UNITED STATES PATENT AND TRADEMARK OFFICE

Office Action Summary

10/634,176

TEOH ET AL.

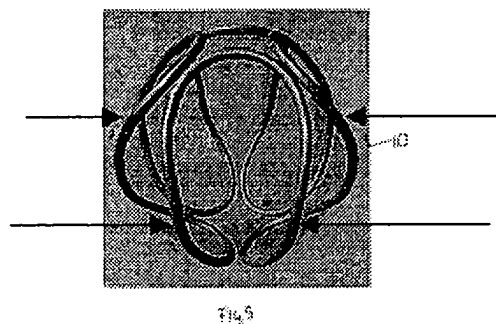
Applicant argues that there are at least four places in which the various loops seem to overlap in Ferrera devices as indicated by the arrow (see below).

Examiner disagrees since the device as claimed having the same overlapping configuration as indicated by the applicant shown in figure 2 above.

Therefore, Examiner considers a non-overlapping loops as the loops being joined together side by side to form a box or a cube shape without interlacing (see figures 2 and 3). Clearly, the loops as shown in figure 2 of Ferrera et al. reference are not interlacing.
